DRAINAGE REPORT & PLAN

CARLISLE PLAZA ADDITION

ALBUQUERQUE NEW MEXICO

RE: DRAINAGE REPORT FOR CARLISLE PLAZA ADDITION

CARLISLE PLAZA ADDITION
SITE & GRADING PLAN

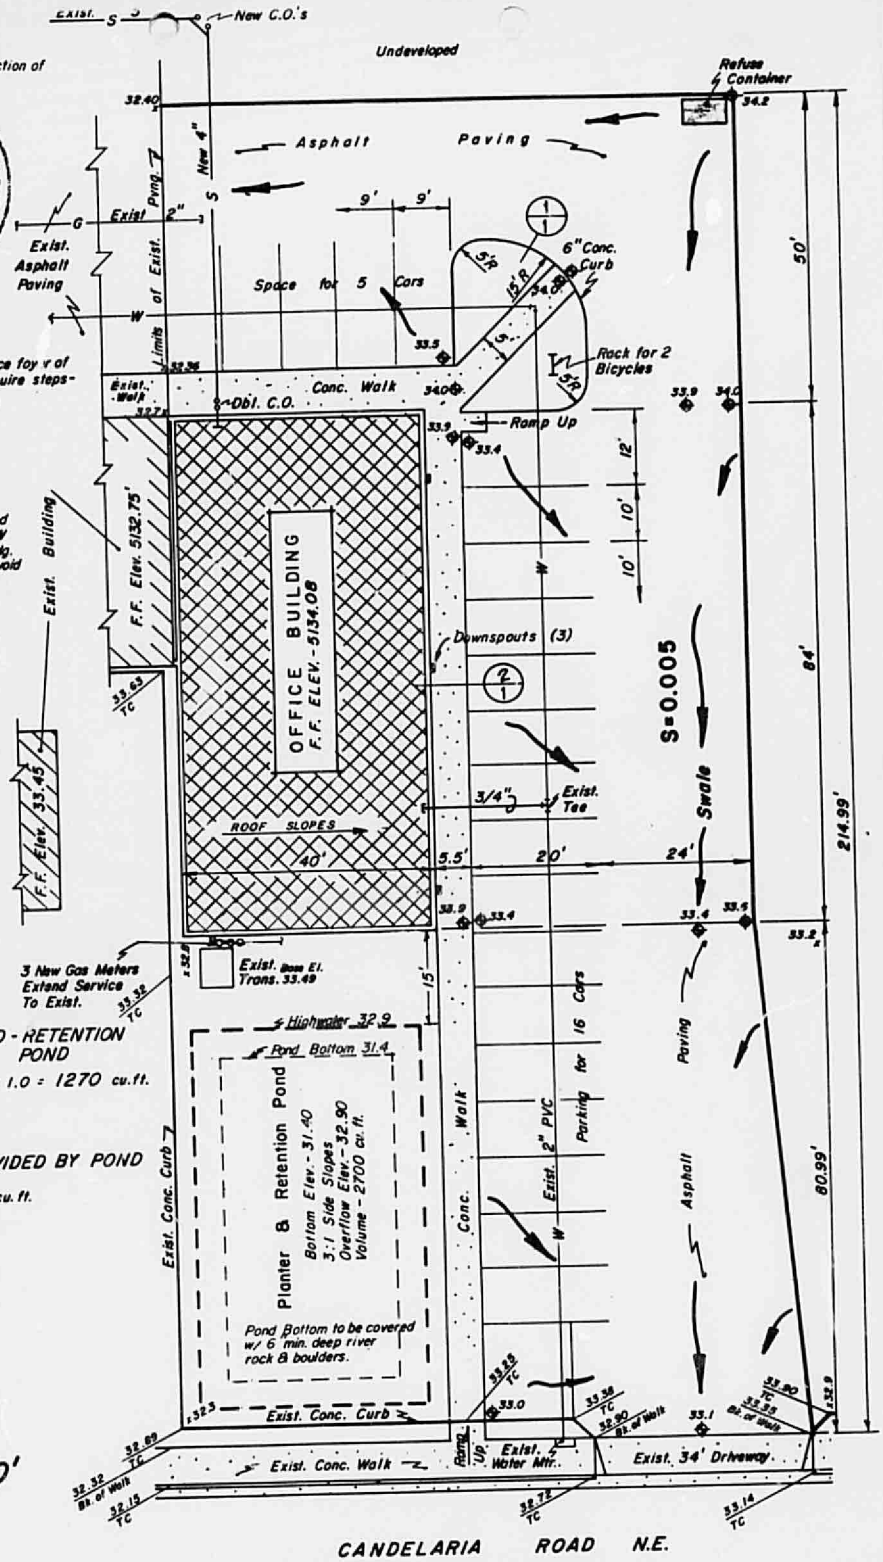
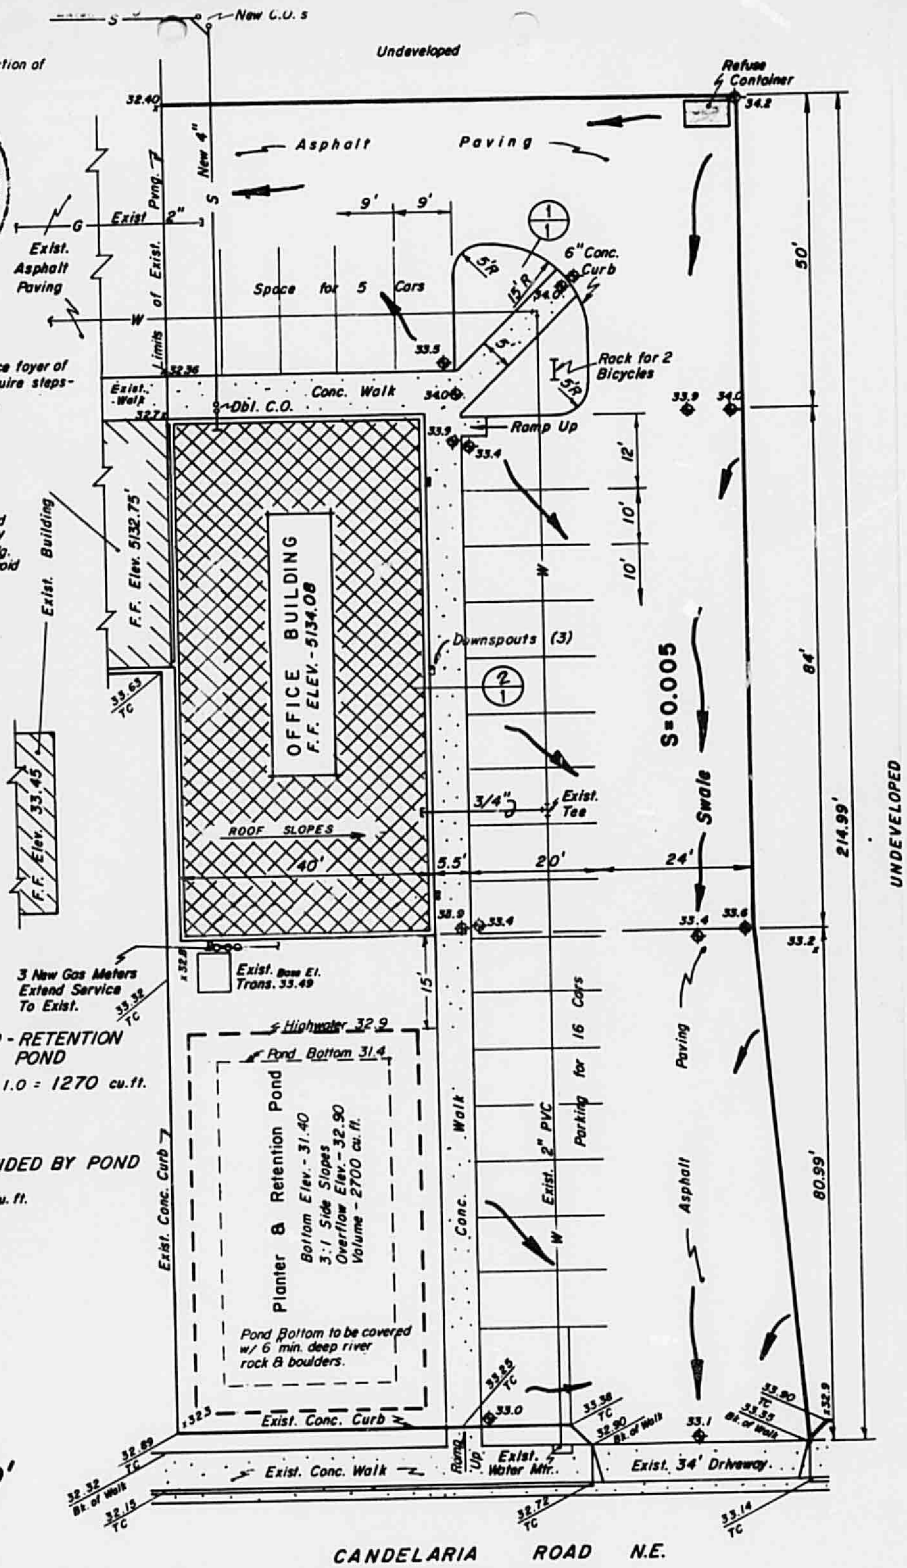
a) I am a bit concerned about placing a scupper directly across from the existing transformer. It appears from the site and grading plan that if the location of the scupper was altered, the roof pattern would require modification. How do you feel about this?

b) Current guidelines prohibit a pond being placed within 15 feet of a structure. Since there is excess capacity available, I suggest moving the pond limits southward so that runoff will not be next to the building.

c) Please provide the following information on the grading plan:

1. Note indicating that the pond will be covered with gravel.

2. Finished floor elevation indicated with mean sea level designation.

I have reviewed your letter containing your comments on the subject drainage report and am in agreement with your concerns and suggestions contained in your paragraphs a) and b). The plans have been revised to reflect this.

The information you asked be shown on the plans in your paragraph c) has been added.

* NOTE:
Storm water discharged from scupper at the SW corner of proposed bldg. shall be diverted to avoid exist. transformer.
